Product Change Notification (PCN)

PCN Number	500819	Date Issued	May 24, 2016
Product Family	Please refer to the full part list attachment for details.		
Series	Please refer to the full part list attachment for details.		
Reason for Change	Capacity change or tool replacement		
Change Type Description	This letter is to inform you that another set of tooling is being added to meet the current and future demands of this product. There will be no changes in the fit, form or function from the additional tooling when compared to the current tooling. See pictures below for more information.		
Reason for Short Notice	New Capacity		
Assessment of Change	Product will be fully qualified before it is shipped. Qualification reports are available upon request.		
Internal Molex Qualification Date	July 05, 2016		
Sample Availability Date (Changed Part)	July 05, 2016		
Planned Implementation Date	July 05, 2016		
Method of Identifying Change	Product made after planned implementation date can contain the change

Before Change

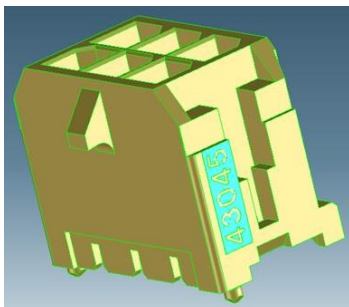
Housing from the
current mold

Housing from the new mold
with no fit, form or function
changes.
